Nature of Work: TEAR OFF & REROOF 19 SQ'S W/ BAR LIGHT-WEIGHT TILE.

re: Job 2001285: Holt located at 5740 8th Avenue, Sacramento, CA
subject: Attachment of new 2x6 purlin to existing 2x4 flat purlin

Subject: Structural Investigation Report of the Roof for the Residence located at 5740 8th Avenue, Sacramento, CA 95820.

PURLIN DETAIL

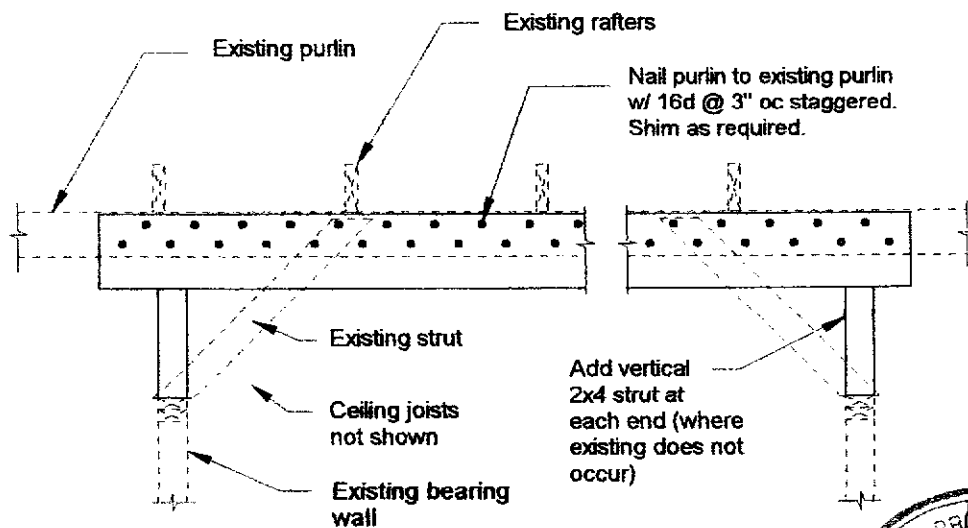
The new 2x6 purlin cannot be nailed to the existing 2x4 flat purlin per detail 2 of the report dated 9/12/2001. Therefore, nail the new 2x6 purlin to the existing 2x4 flat purlin with 16d's spaced at 12" on center in lieu of the 16d's @ 3" on center staggered per detail 2.
